KAKE DOLPHIN REPLACEMENT & BRIDGE REHAB
FED. NO. STP-0939(6) ~ PROJECT NO. 75525
QUANTITIES & GENERAL NOTES

KAKE DOLPHIN REPLACEMENT & BRIDGE REHAB
FED. NO. STP-0939(6) ~ PROJECT NO. 75525
DOLPHIN STRUCTURE PLAN & ELEVATION

KAKE DOLPHIN REPLACEMENT & BRIDGE REHAB
PROJECT NO. STP-0939(6)/75525
DOLPHIN STRUCTURE CAP DETAILS

MOORING STRUCTURE PLAN

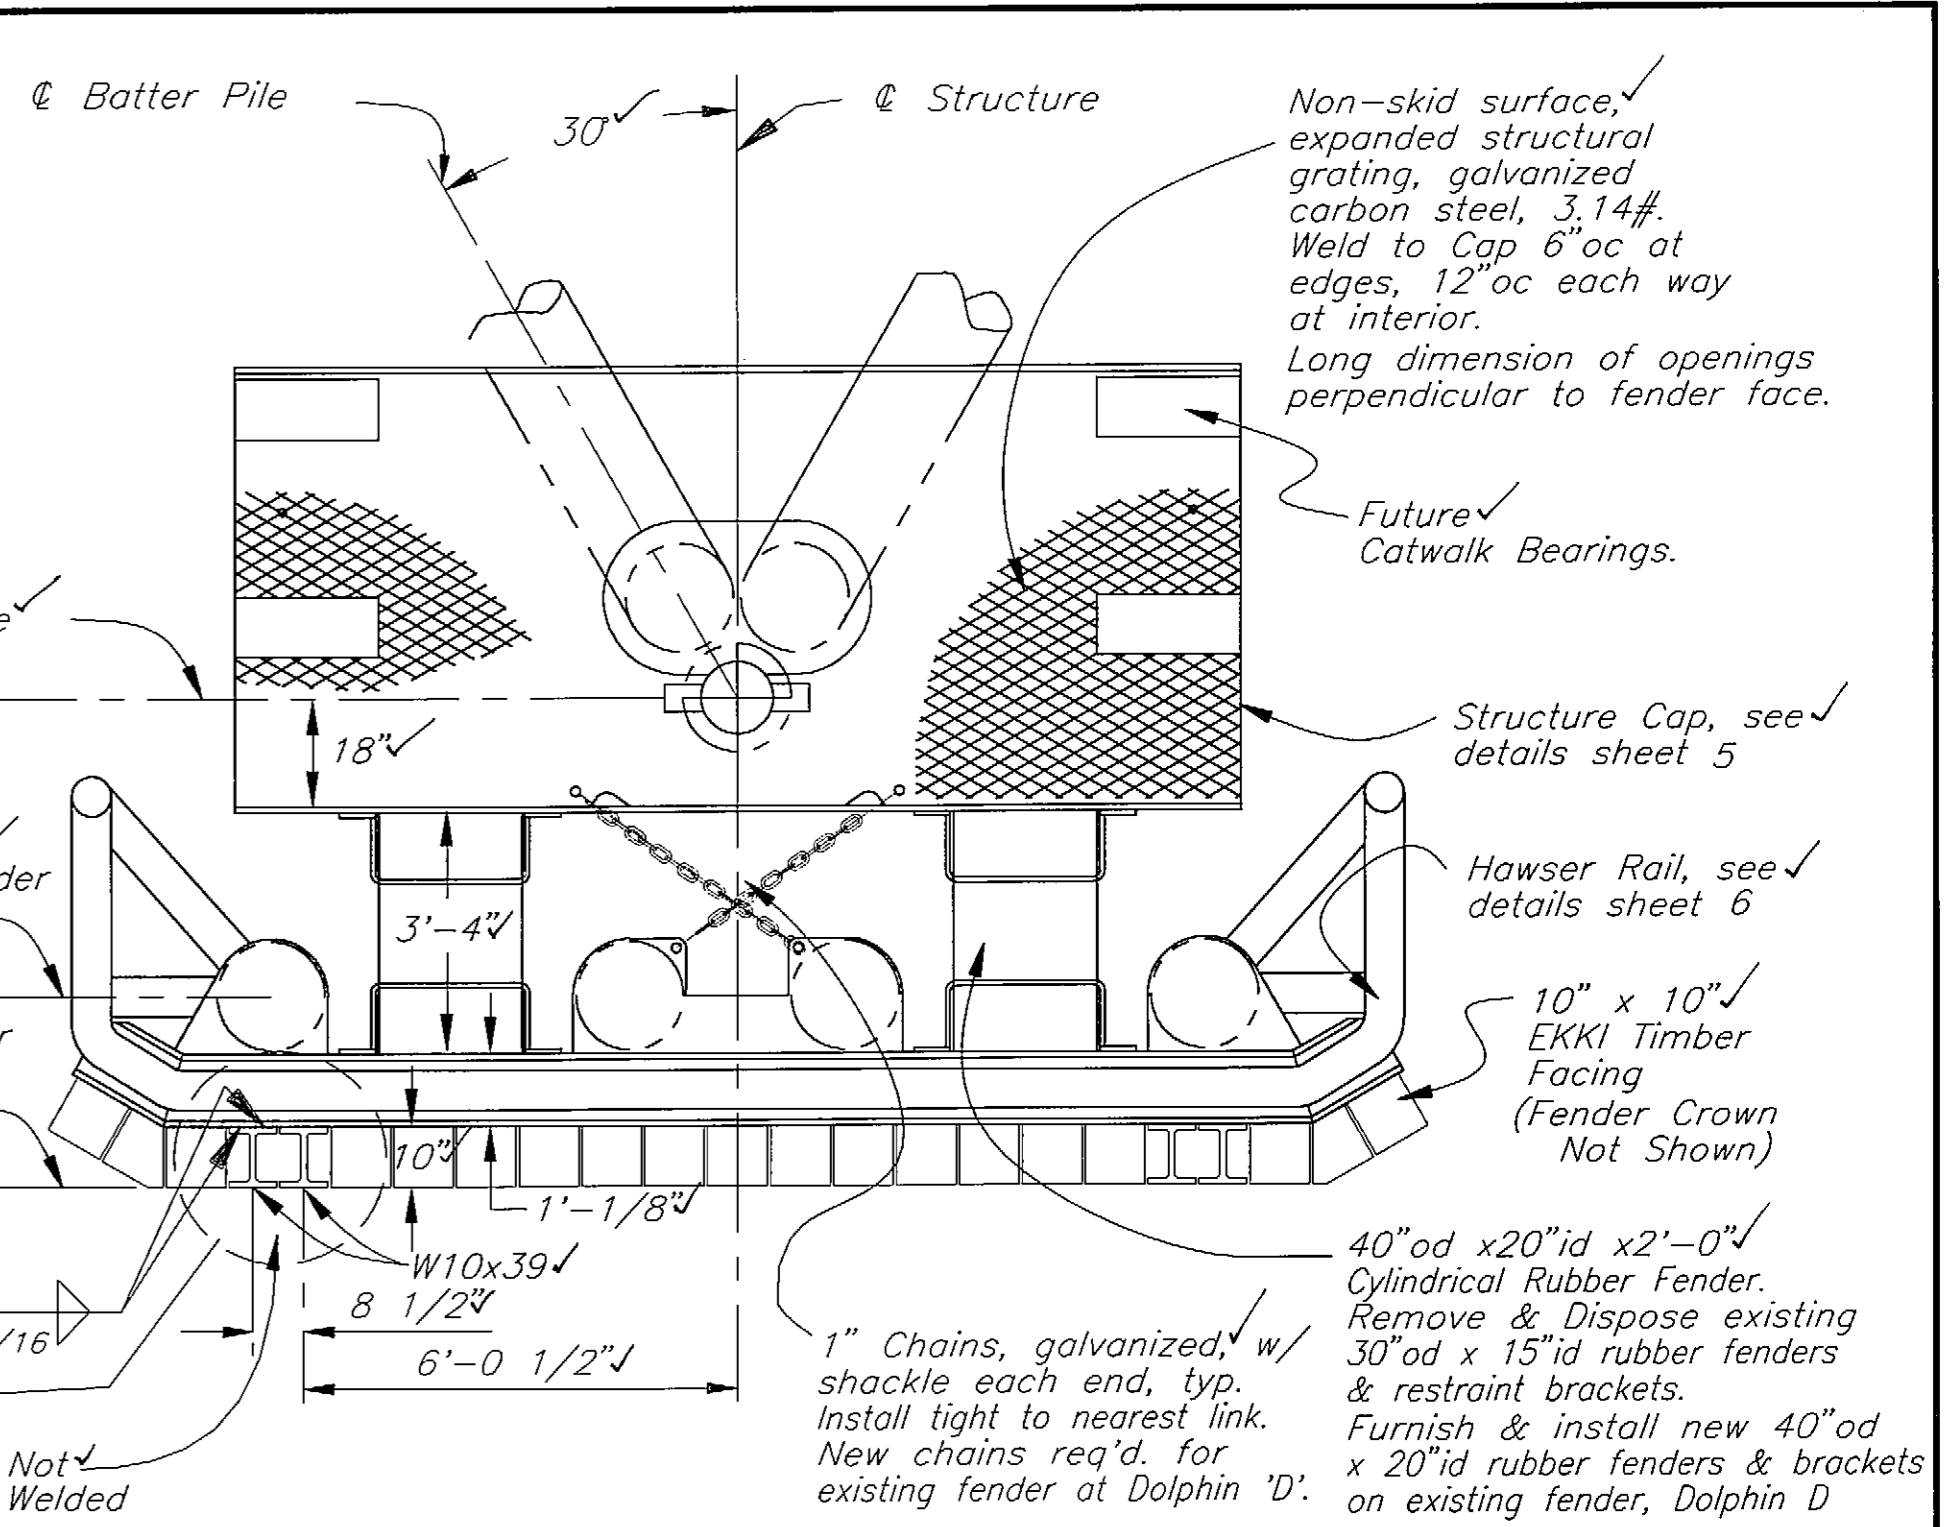
NOTE: ALL DIMENSIONS WITHIN ALLOWABLE TOLERANCES

HAWSER DETAIL

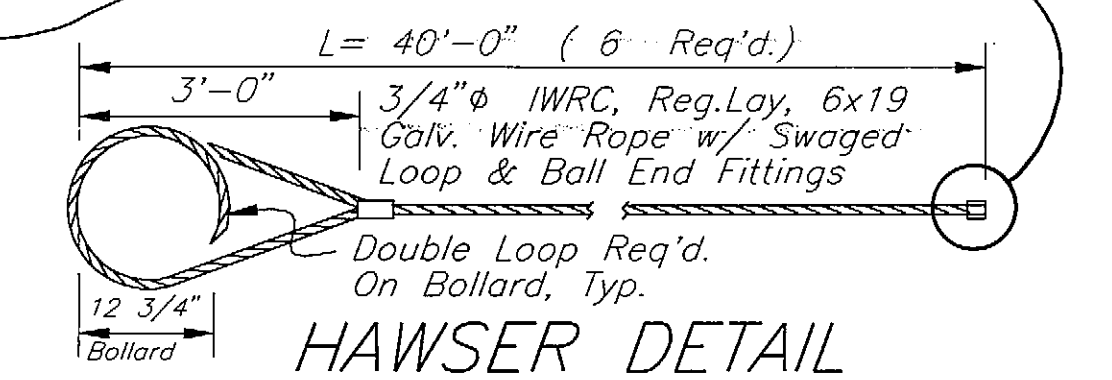
WE DIDN'T SPECIFY DIA FOR SWAGED END. WHAT ARRIVED WAS WRONG SIZE. RE-USED EXISTING & TURNED NEW OVER TO LECONTE CREW.
